Re: Fourth Submission Review – DA 2170-07 – Stafford Logistics Center Commercial – Master Plan  
Amendment, Infrastructure Site Plan, and Plat.  
Application Number: DA-2170-07  
Case Numbers: 2024-3001-00; 2019-7001-04; 2024-6002-00

# STAFFORD LOGISTICS CENTER - COMMERCIAL SITE

## INFRASTRUCTURE SITE PLAN

SHEET	05
Sheet	05 of 30

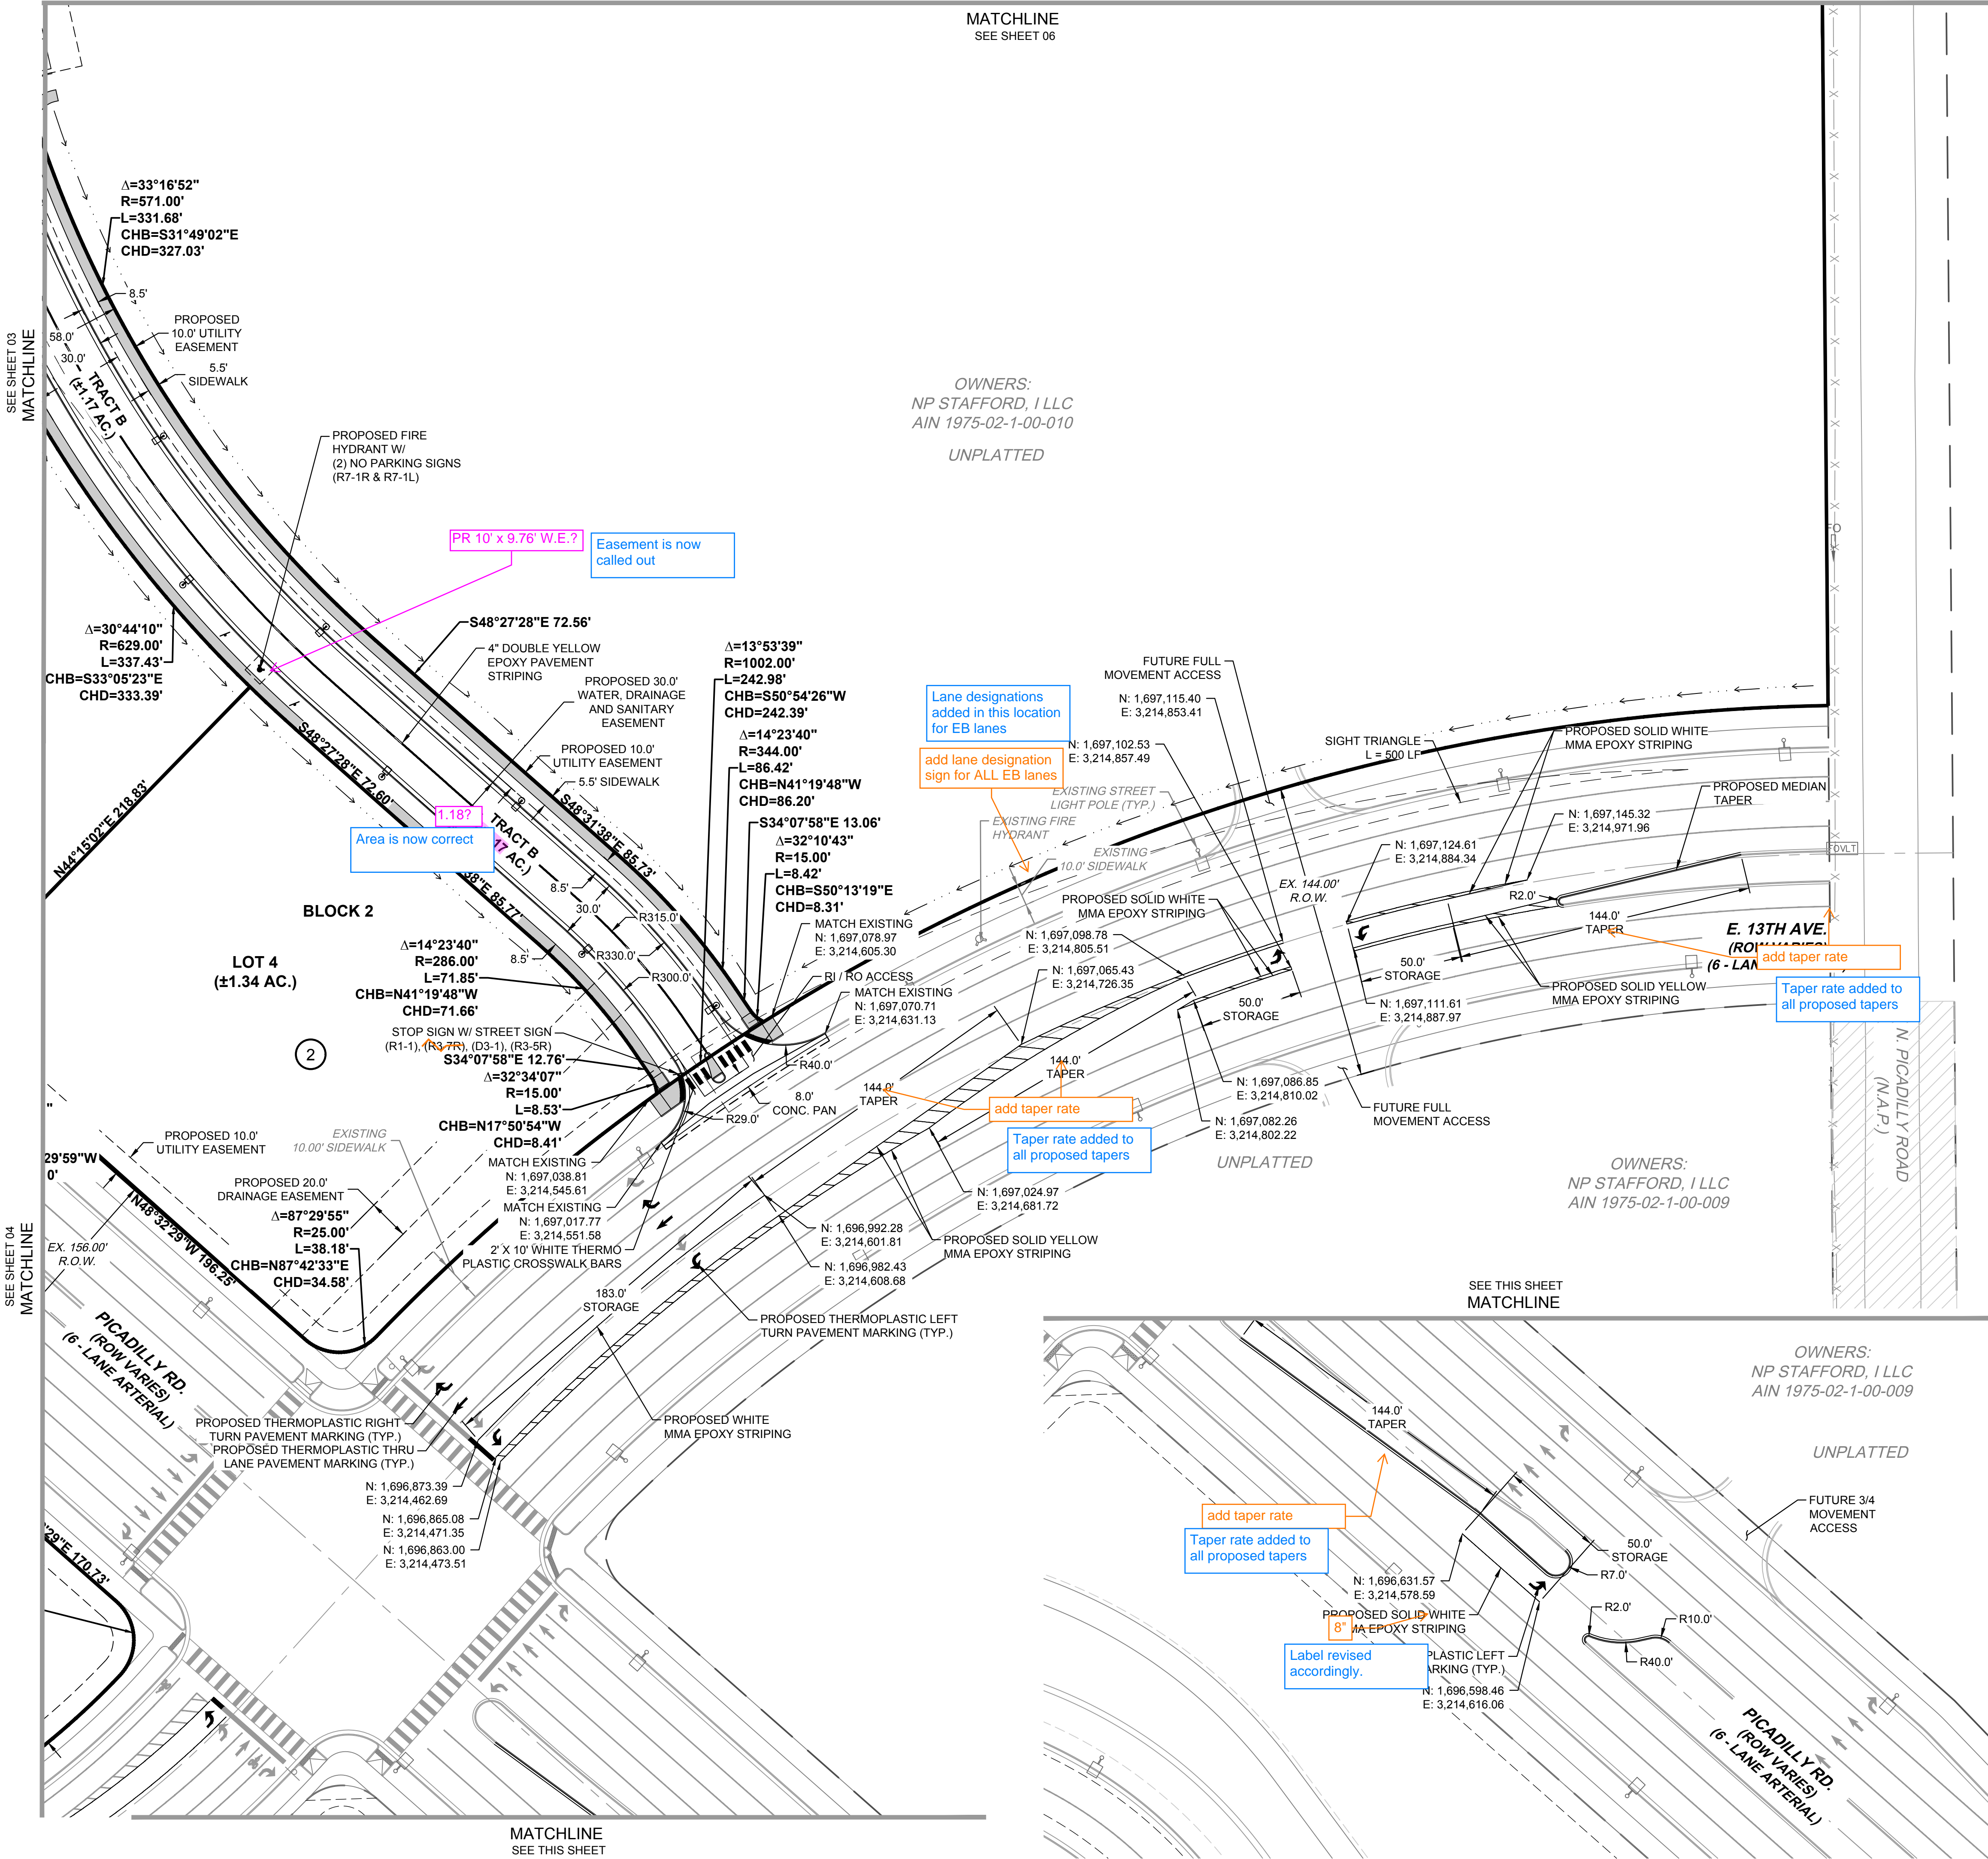
5MM. Sheet 5: Add lane designation sign for ALL EB lanes.

5NN. Sheet 5: Add taper rate, all instances.

- 8L. Sheet 5: Label easements to match the plat and match easement names with the plat.

8M. Sheet 5: Revise the acreage to match the plat.

WM Response: Lane designations added in this location for all EB lanes.

WM Response: Taper rate added to all proposed tapers.

[WM Response: Easements relabeled to match plat.](#)

WM Response: Acreages are now consistent with plat.
